**AP1000 CORE REFERENCE REPORT
DCD (Rev. 19) Change Road Map**

Change No.	Chapter 15 Section 15.2	Change Summary Description
[15.2-1]	15.2.2, Loss of External Electrical Load	Editorial changes incorporated.
[15.2-2]	15.2.3, Turbine Trip	<p>The following changes were incorporated in the updated analysis: increased $F_{\Delta H}$ limit (1.65 to 1.72), use of the digital ΔT signal, increased rod drop time for the Safety analysis and the updated valve, nozzle and piping pressure loss coefficients.</p> <p>Additionally, the moderator density function was modeled as a function of density.</p>
[15.2-3]	15.2.6, Loss of ac Power to the Plant Auxiliaries	<p>The following changes were incorporated in the updated analysis: increased $F_{\Delta H}$ limit (1.65 to 1.72), containment backpressure effects on PRHR heat transfer, increased rod drop time for the Safety analysis and the updated valve, nozzle and piping pressure loss coefficients.</p> <p>The loss of ac power to the plant auxiliaries case presented in the DCD, where feedwater flow is lost at time zero, and power to the reactor coolant pumps is lost as a result of the turbine trip, was renamed Loss of Normal Feedwater Flow with loss of o

Figure 15.2.7-2
Core Heat Flux Transient for Loss of Normal Feedwater

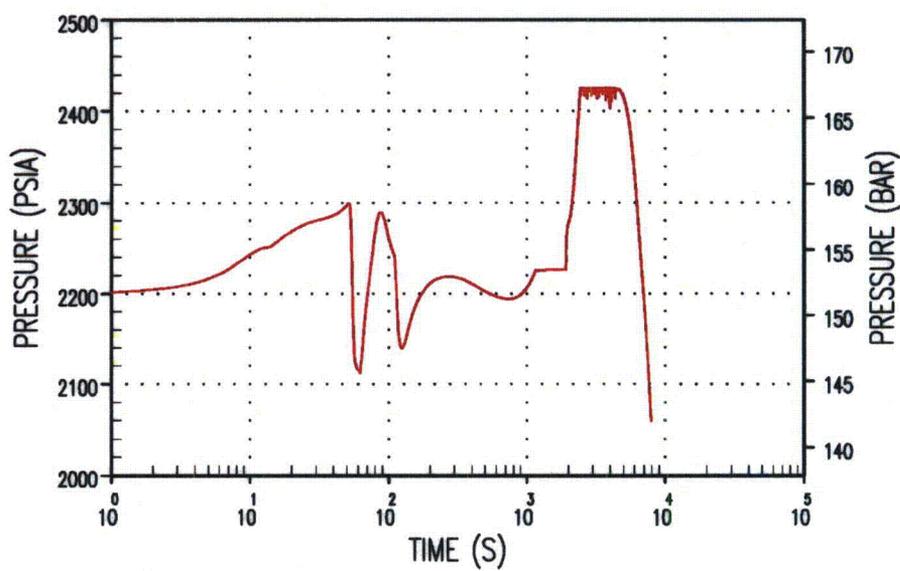
Comment [B9]: [15.2-8]
Deleted: Reactor Coolant System Volumetric Flow
Deleted: Flow

Figure 15.2.7-4

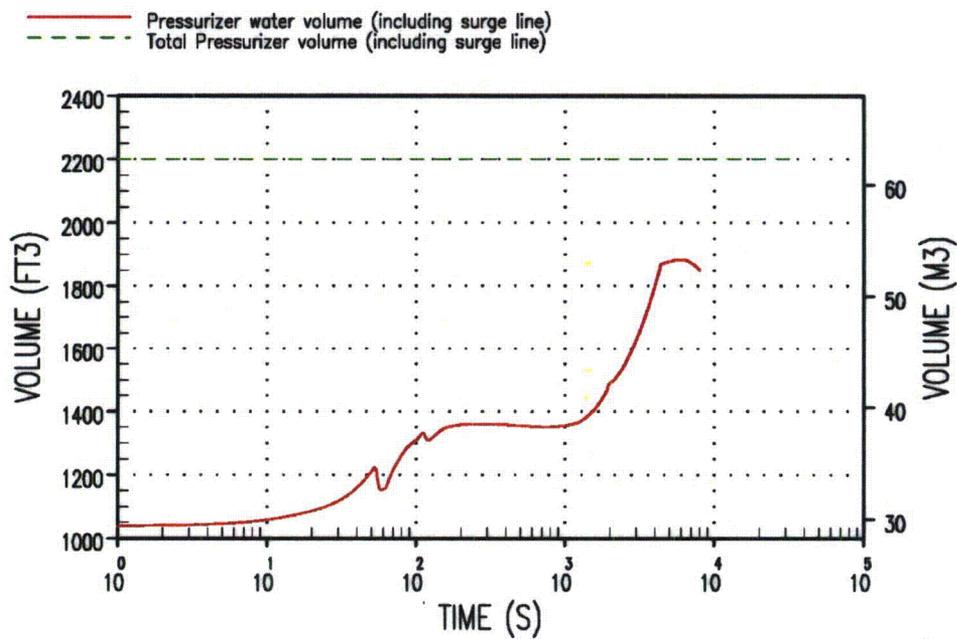
Comment [B11]: [15.2-8]

Figure 15.2.7-5

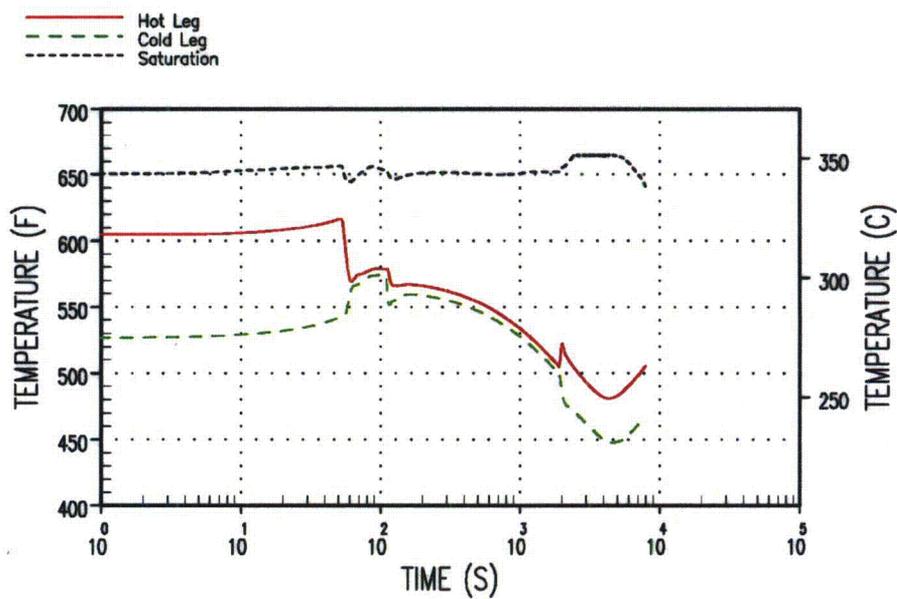
Comment [B12]: [15.2-8]

Figure 15.2.7-8

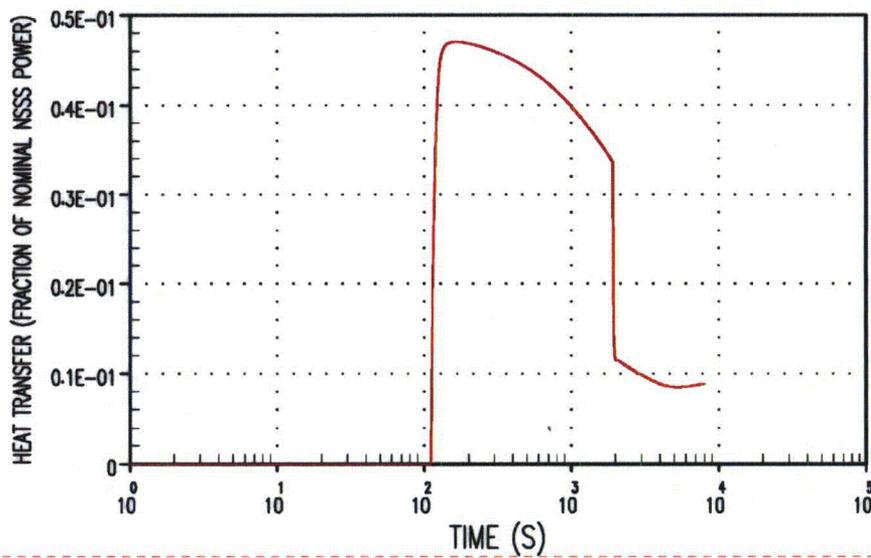
Comment [B15]: [15.2-8]
Deleted: Steam Generator
Inventory...RHR Flow P... [46]

Figure 15.2.7-10

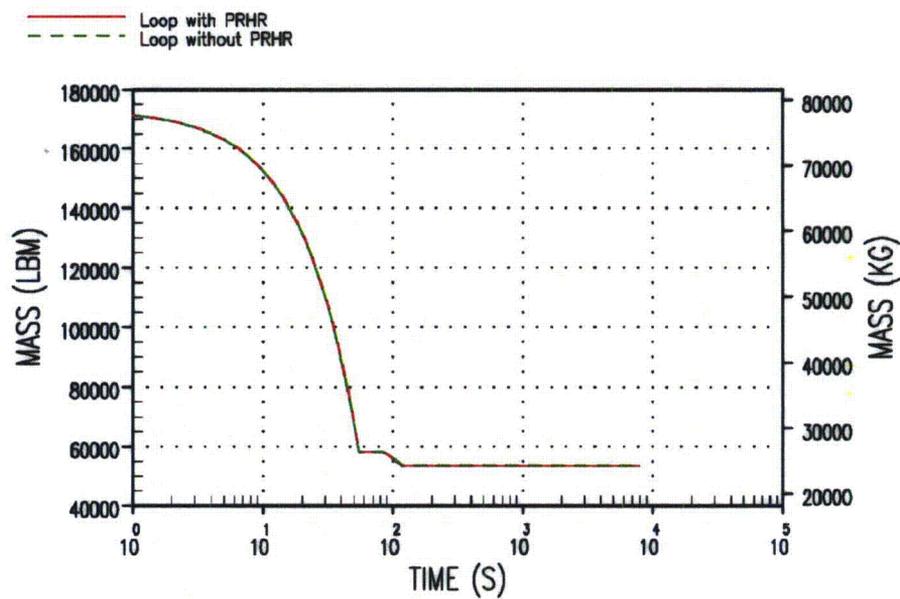
Comment [B18]: [15.2-8]

Figure 15.2.7-13

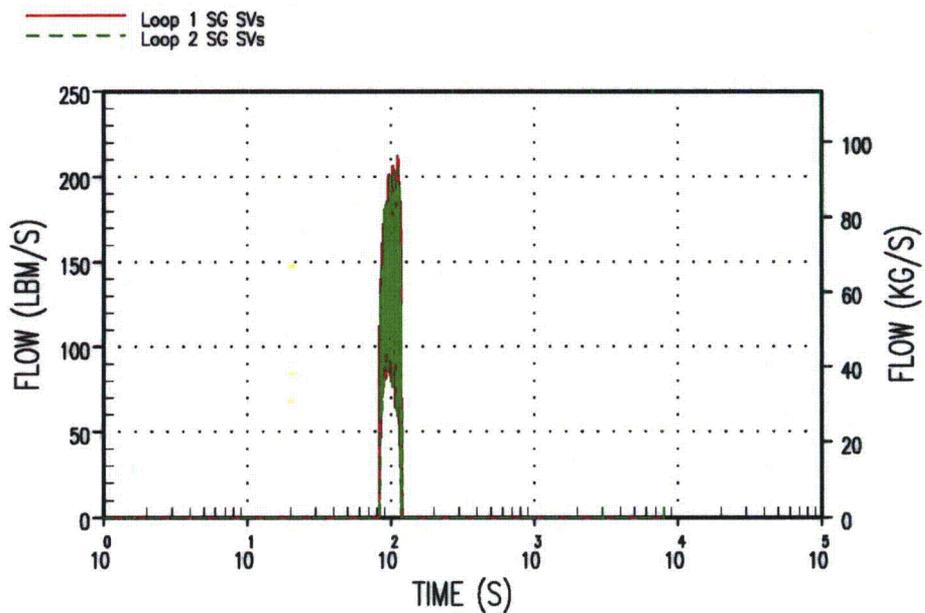
Comment [B20]: [15.2-8]
